BEFORE
THE PUBLIC SERVICE COMMISSION
OF SOUTH CAROLINA
DOCKET NO. 2019-185-E

IN RE: South Carolina Energy Freedom Act (H.3659) Proceeding to Establish Duke Energy Carolinas, LLC's Standard Offer, Avoided Cost Methodologies, Form Contract Power Purchase Agreements, Commitment to Sell Forms, and Any Other Terms or Conditions Necessary (Includes Small Power Producers as Defined in 16 United States Code 796, as Amended) - S.C. Code Ann. Section 5841-20(A)	)	**AMENDED DIRECT TESTIMONY OF ED BURGESS ON BEHALF OF SOUTH CAROLINA SOLAR BUSINESS ALLIANCE**

Figure 4. Peaker technology cost screen from Duke's 2018 IRP

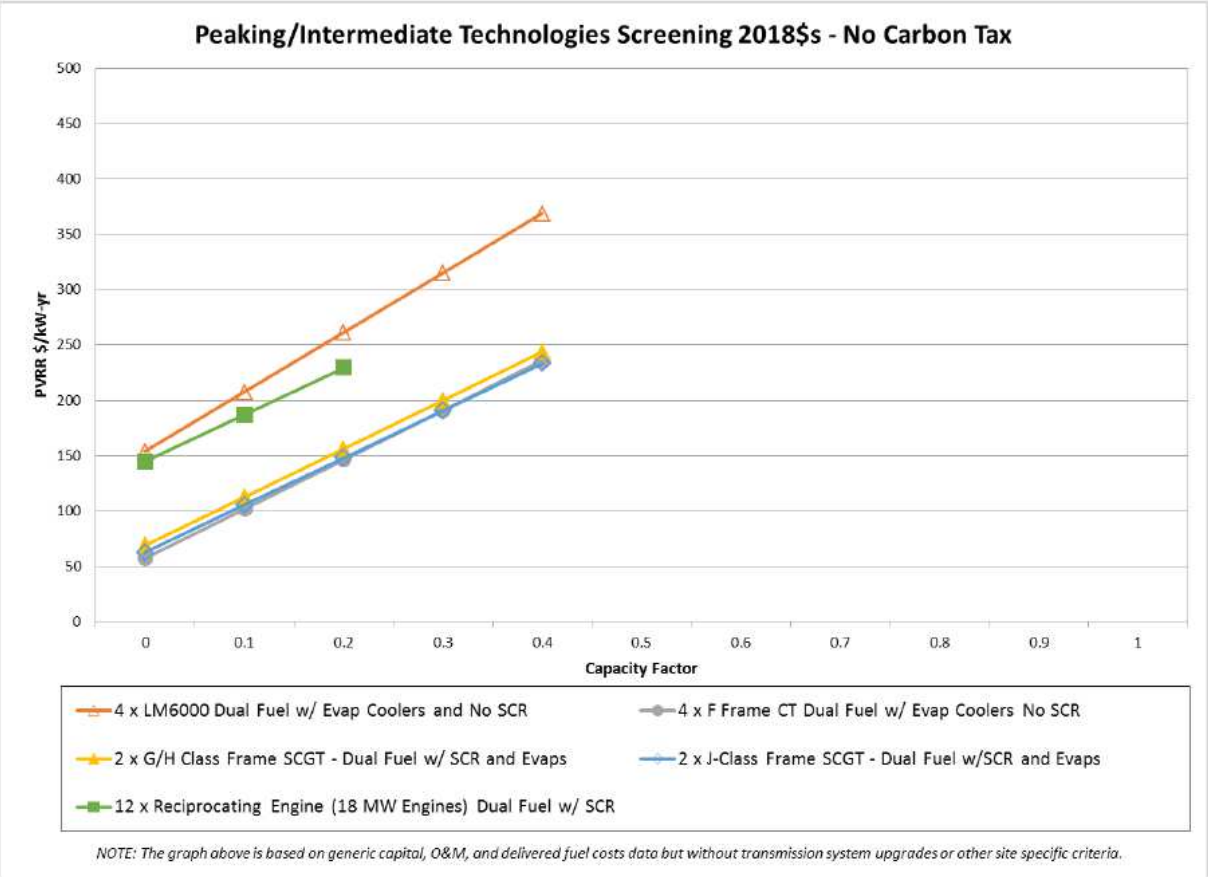
factor for 'economies of scale', which reduces the initial capital cost by [redacted]. Duke argues that this adjustment is warranted since building a 4-unit combustion turbine (CT) plant would reduce the per-unit cost of each unit due to common costs associated with land, buildings, roads, security, gas interconnection, and other infrastructure relative when compared to a single 237 MW unit.

A. Yes. For calculating the avoided capacity costs, Duke has selected the lowest cost available peaking unit included in EIA's predetermined list of potential generation technologies. This does not necessarily correspond to the cost of the peaking unit that Duke would ultimately select to meet future peak demand or provide other services.

For comparison, Duke's 2018 IRP suggested that the fixed costs of an aeroderivative CT (LM6000, 0% capacity factor) was approximately 2-3 times that of an advanced frame CT (see Figure 4 above). This is consistent with cost estimates I have observed from other utilities. For example, in its 2018 IRP

Figure 4: Uncontrolled Solar-Only Facility 5-Minute Output

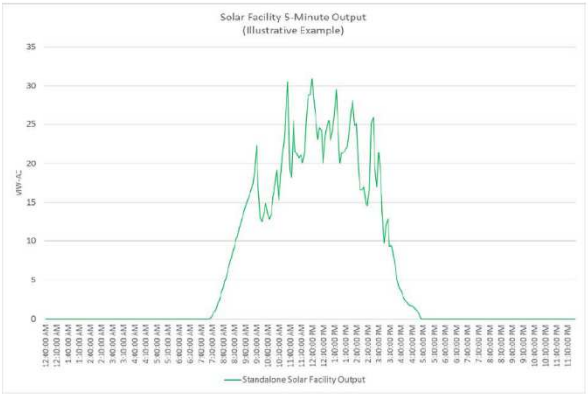
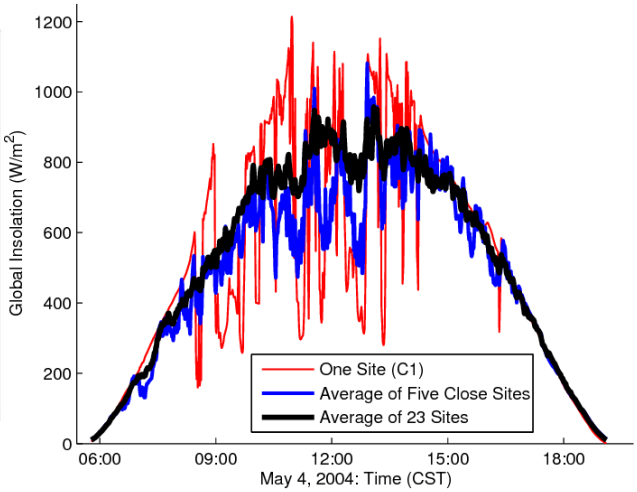
Q. How does Duke's study treat this minute-to-minute variability in solar output?

A. Duke includes a "volatility profile" to simulate this variability. However, the approach is flawed. The study scales up the variability in a linear fashion, as if ~~the~~all future solar output ~~all~~ occurred in ~~the exact same location~~fixed locations. If the profiles were distributed across a broader geography (as is likely to occur in reality), the volatility would be greatly reduced.
